# Access Compliance Report

Intersection ID: 9562	Main Street: CHESHIRE_AV	Cross Street: SANTEE_ST	Location:	N
ADA ID: 310116F23FCE	Ramp Type: Perp	Initial Pass/Fail: Fail	Overall Compliance: No	Severity Score: 26.25
Codes/Mitigation Info/Possible Solution		Field Measurements/Component Compliance

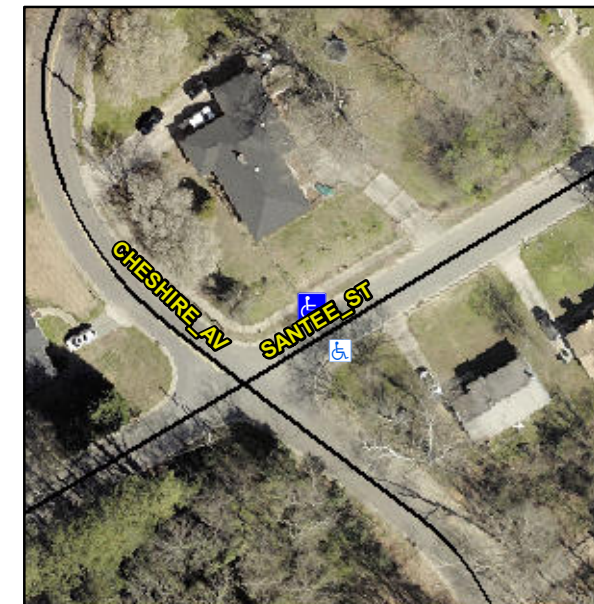
**Not Found, R304.2.2**

Compliance	Description	Data	Compliance	Description	Data
N/A	Ramp Length (in)	48.0	No	Ramp Slope (%)	13.9
Yes	Ramp Width (in)	48.0	Yes	Ramp XSlope (%)	3.3
N/A	Flare Type LT	N/A	N/A	Flare Type RT	N/A
N/A	Flare Slope LT (%)	N/A	N/A	Flare Slope RT (%)	N/A
N/A	Flare Traversable LT?	N/A	N/A	Flare Traversable RT?	N/A
N/A	Landing Length (in)	N/A	N/A	DWS Provided?	N/A
N/A	Landing Width (in)	N/A	N/A	DWS Contrast?	N/A
N/A	Landing Slope (%)	N/A	N/A	DWS Length (in)	N/A
N/A	Landing X Slope (%)	N/A	N/A	DWS Full Width?	N/A
N/A	Landing Curb? (Y/N)	N/A	N/A	DWS Offset (in)	N/A
N/A	Shared Landing?	N/A			
N/A	Gutter Ponding?	N/A	N/A	Gutter Slope (%)	N/A
N/A	Gutter Lip Ht (in)	N/A	N/A	Gutter X Slope (%)	N/A
N/A	Painted X Walk1?	No	N/A	Painted X Walk2?	N/A
	X Walk 1 Direction	To S		X Walk 2 Direction	N/A
N/A	X Walk 1 Width (in)	N/A	N/A	X Walk 2 Width (in)	N/A
	X Walk 1 Slope (%)	0.4		X Walk 2 Slope (%)	N/A
	X Walk 1 X Slope (%)	3.6		X Walk 2 X Slope (%)	N/A

**Remove & Replace Entire Ramp.**
